Comments on the EIS for Mingara Recreation Club Seniors Housing Tumbi Umbi

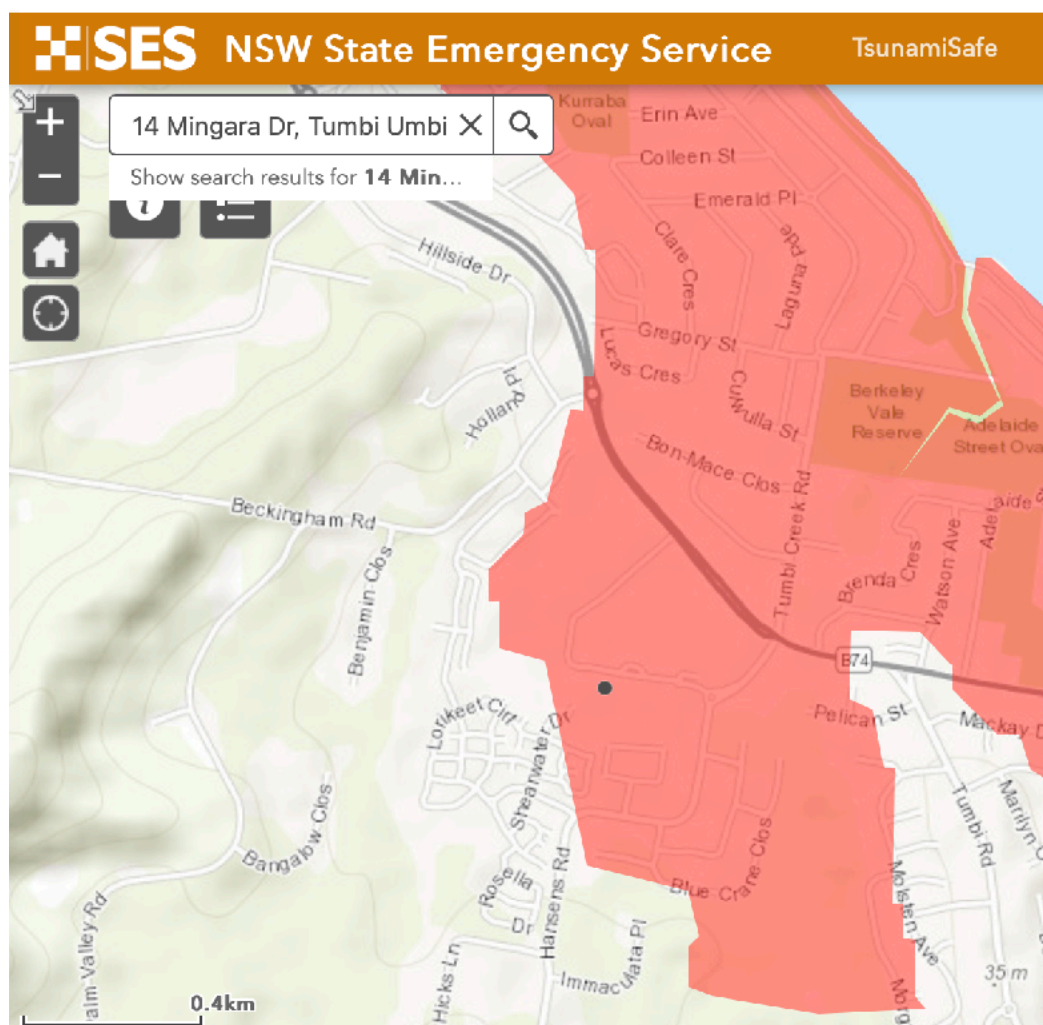
While the Flood Emergency Management plan is commendable as an operational procedure, it seems an unfortunate oversight of the SEARs that the EIS does not acknowledge that the NSW SES rates parts of the development site as being at risk of tsunami (see screenshot below or visit <https://www.ses.nsw.gov.au/plan-and-prepare/tsunami/evacuation-map>).

If the Bureau of Meteorology were to issue a Land Inundation Threat Warning, SES advise that residents need to move to ground more than ten metres above sea level. No part of the development site is that high. The NSW topographical map shows the nearest public land above 10 metres is to the west of the development site in the vicinity of Beckingham Road.

However, any tsunami would arrive from the north via Tuggerah Lake making the nearest pedestrian or motor evacuation route in that direction unwise despite the urgency. Perhaps sheltering in place may be an option for some ILUs, particularly on upper floors. The Flood Emergency Management Plan concludes that "...the most appropriate evacuation procedure [in the case of flash flooding coming from the south or west] is considered to be vertical evacuation, or shelter in place, specifically for mobility impaired occupants (Appendix LL p23).

Given that residents of the proposed development will be seniors and perhaps frail aged, this missing analysis in the EIS is concerning.

- n) The Director seems remiss in not requiring the EIS to analyse the impact of tsunami inundation.
- o) Expert advice on a suitable action plan in the case of tsunami emergency seems warranted.
